WATER LICENCE INSPECTION FORM

Hamlet of Cape [Dorset		Bhabesh Roy		
Licence No. / Expiry			Representative's Ti		
3BM-CAP1925			Municipal En		
Land / Other Authorizati	ons		Land / Other Autho	rizations	
Date of Inspection			Inspector		
July 29, 2021			Joseph Mont	eith	
Activities Inspected			JOSEPH WIGHT	Citii	
☐ Camp	☐ Drilling	Mining	Construction	n Reclamation	☐ Fuel Storage
☐ Roads/Hauling	Other: Potable Wate Treatment, Solid Waste Waste Facility		Other:		
Conditions:	A- Acceptable	U-Unacceptable	C-Concern	NI-Not Inspected	NA- Not applicable
PART:				Condition	Observation No.*
A: SCOPE, DEFINITIO	NS AND ENFORCEME	NT		NA	
B: GENERAL CONDIT	TONS			С	1-3
C: CONDITIONS APP	LYING TO SECURITY			NI	
D: CONDITIONS APP	PLYING TO WATER USE	Ē		Α	4-9
E: CONDITIONS APP	LYING TO WASTE DIS	POSAL AND MANAGE	EMENT	С	10-20
F: CONDITIONS APPI	LYING TO MODIFICATI	ONS		NI	
G: CONDITIONS APP	PLYING TO CONSTRUC	TION		NI	
H: CONDITIONS APP	H: CONDITIONS APPLYING TO EMERGENCY RESPONSE AND CONTINGENCY		С

On July 29, 2021, a water license inspection was conducted at the Hamlet of Cape Dorset, Qikiqtani Region, Nunavut, by Water Resource Officer (WRO) Joseph Monteith, to verify terms and conditions of the

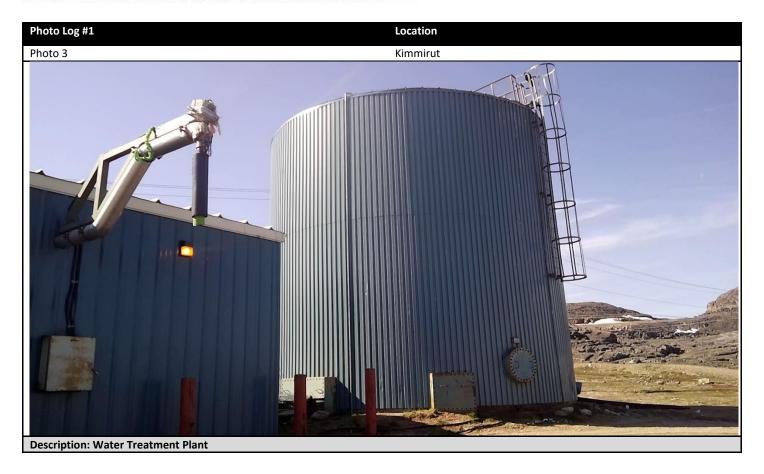
Description: A berm rebuilt into the solid waste facility is overflowing. The water being built up has to be tested and treated if found to have contaminants before being released.

- Test the bermed water inside the solid waste facility, and provide results to the inspector, and submit results in 2021 Annual Report.
- The Licensee is reminded to remain diligent to prevent wastes from entering water, and the environment.

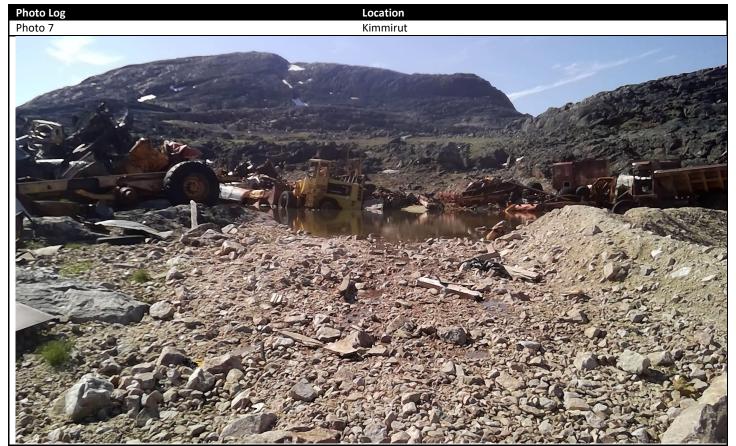
Description: 3 walled, non-engineered berm for storage of drums of hazardous waste. Active spill coming from drums. Spill of this size was not observed in 2020.

- Send hazardous waste to a proper Hazardous Waste Facility to free up room in the current Hazardous Waste Facility. Keep copies of Hazardous Waste Manifest for verification purposes.

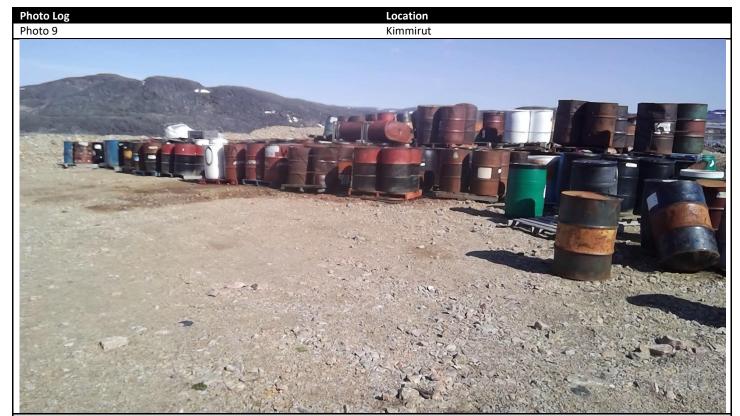
Description: Unreported spill at the emergency lagoon. A spill report submission was requested, and clean up. Walls of emergency sewage lagoon repaired, and 1 metre free board now maintained.
